FSN Ref : PM6/SS14/FSN

Urgent field safety notice Easymoov6 Enteral feeding pump

Urgent Field Safety Notice (FSN) Easymoov6 Enteral feeding pump Risk addressed by FSN

Appendix 1 : Reminder on tubing installation on Eaymoov6 enteral feeding pumps

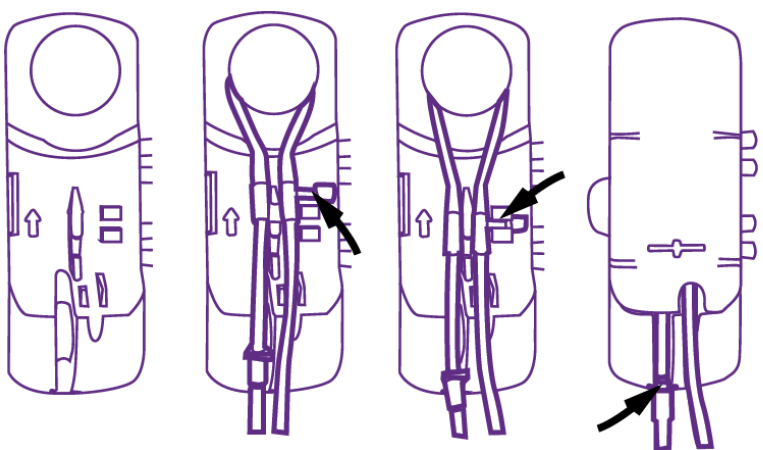
- **not to connect the tubing to the probe** before priming,
- **to check the correct position of the silicone tube** around the rotor:

(1) Open Easymoov6 pump cover.	
(2) Place the silicone loop around the rotor and make sure the cassette is in the right direction.	
(3) Push the cassette in the middle of the pins with your thumb and make sure the cassette is well positioned between the two black pins. Guide both tubes down, in line with their respective slots.	
(4) Close the pump cover, then place the adapter into the designated slot.	
Remove the protective cap from the tubing.	
Launch automatic priming (see section 3.5).	
Connect the tubing to the patient enteral feeding tube and program the pump.
